# ADDENDUM

Project Name:	Project Name: Enclosed Commons	Addendum No.:	<b>Two (2)</b>
	Owner's Name: Grady ISD	Date:	3/18/10
	Street Address: 3500 FM 829.	Project No.:	07031.7
	City, State Zip: Lenorah, Texas 79749

SUPPLEMENTAL DRAWING NO. SD-19

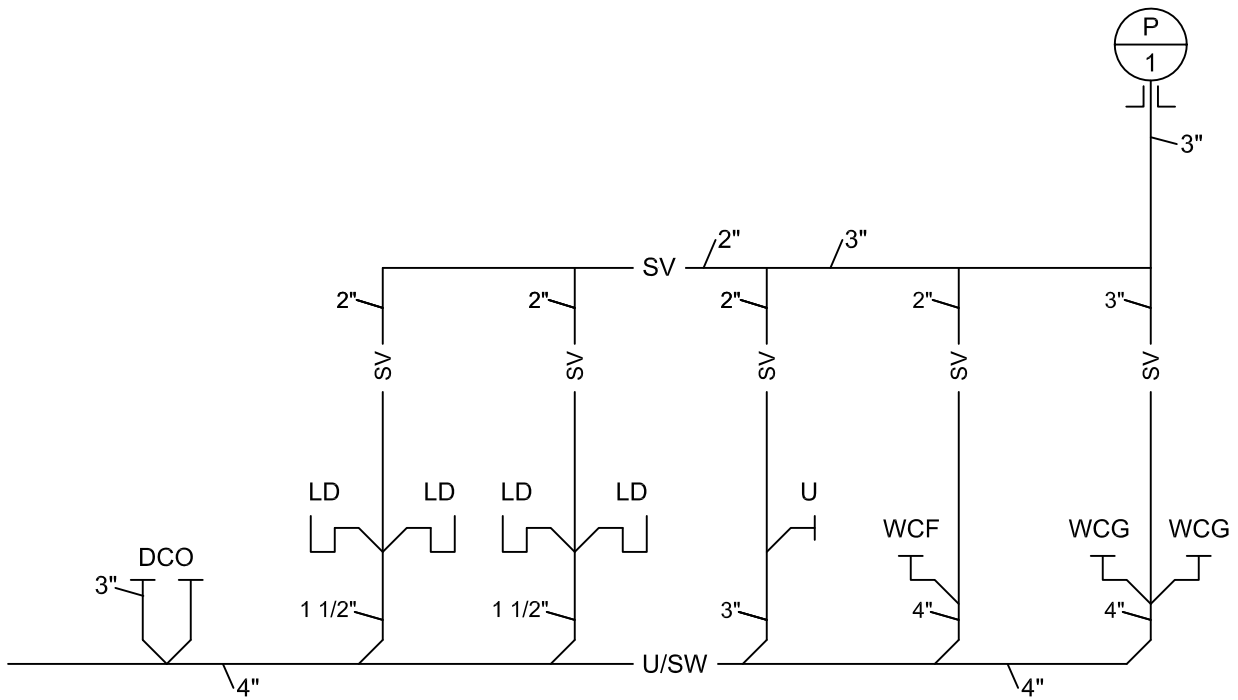
- Item No. Four:** In the Drawings, Sheet P2- Plumbing Plan – Area A, Provide the plumbing fixtures, U/SW, SV, and CW pipe to accommodate the changes made to Girls A107 and Boys A105 as shown on the supplemental drawings SD-19 and SD-20 attached herewith.

- Item No. Five:** In the Drawings, Sheet P2- Plumbing Plan – Area A, Add Note Number thirteen as follows;  
 (13) PROVIDE NEW CW PIPE AND SHUTOFF VALVE AS SHOWN. ROUTE NEW CW PIPE DOWN INSIDE CHASE TO SERVE NEW PLUMBING FIXTURES.
